SERVICE BULLETIN SB00.11

Machines/Models: AB46 RT

PURPOSE: Enhance the durability of the Front Axle

PROCEDURE REQUIRED: Replace the Front Axle and install Chassis Reinforcement Plates

Figure 1

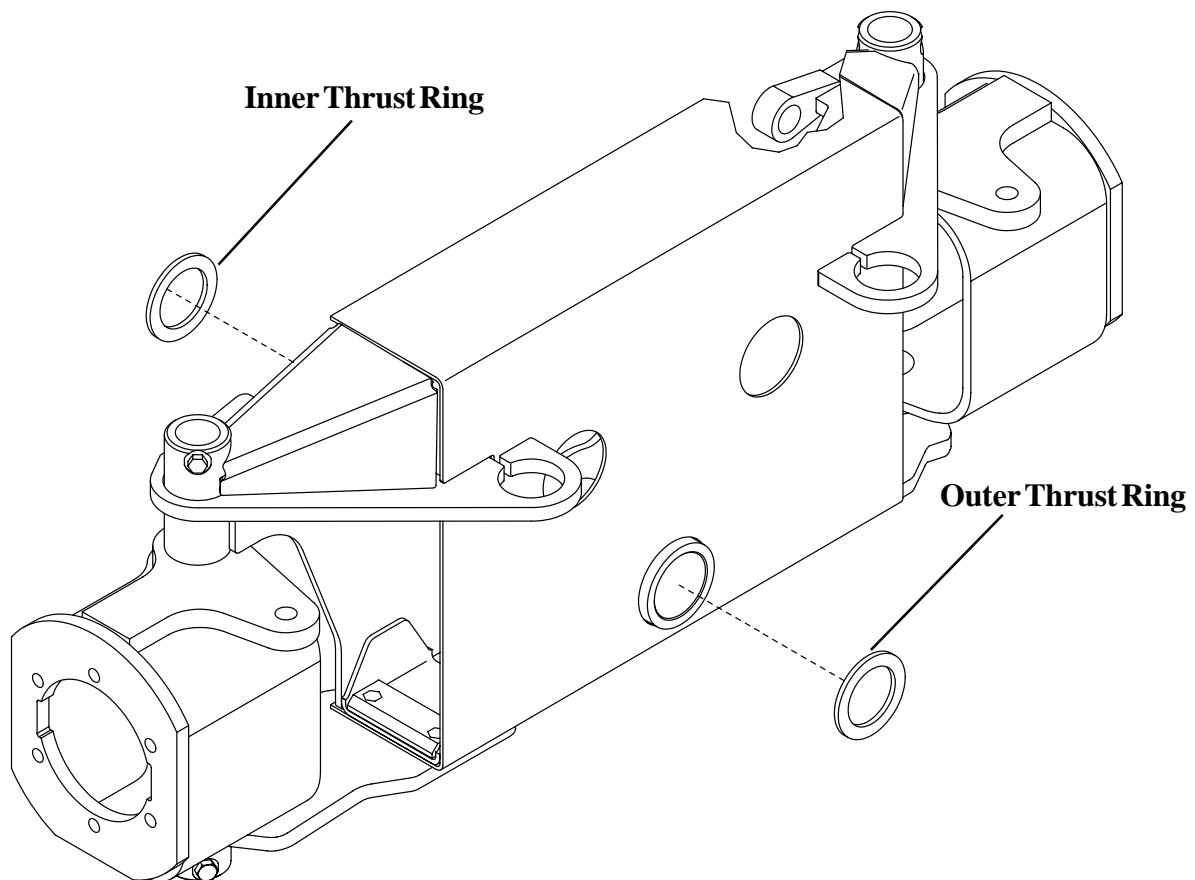
7. Remove the Axle Float Cylinder attachment pins from the Front Axle (retain for reinstallation).
8. Remove the Front Axle Retaining Collar, Hardware and Outer Thrust Ring (Figure 1).

9. Using a suitable lifting device, support the Front Axle Weldment and remove it from the chassis.
10. Remove the Inner Thrust Ring and discard.
11. Install the supplied Inner Thrust Ring (P.N. 068869-001) on the Chassis Pivot Pin (Figure 1).

12. Using a suitable lifting device install the supplied Front Axle Weldment (P.N. 068835-001).
13. Install the Outer Thrust Ring (P.N. 068869-001) (Figure 1).

Figure2 Shown upside down for clarity.

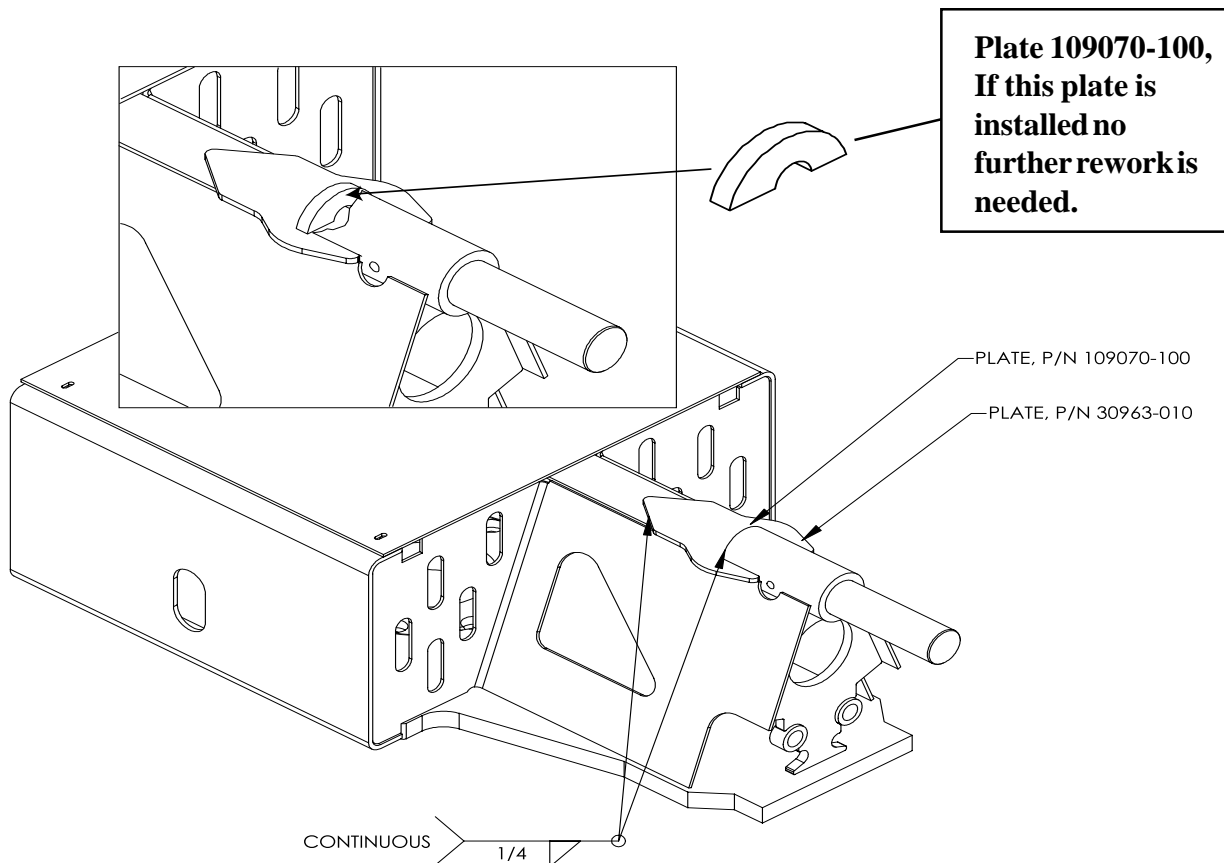
BEFORE DOING STEPS 21-23 INSPECT THE MACHINE, IF ENFORCEMENT PLATE 109070-100(SEE FIGURE 2), WAS FACTORY INSTALLED NO FURTHER RE-WORK IS NEEDED

21. Attach the Chassis reinforcement plates (P.N. 109070-100 and 030963-010) per fig 2.
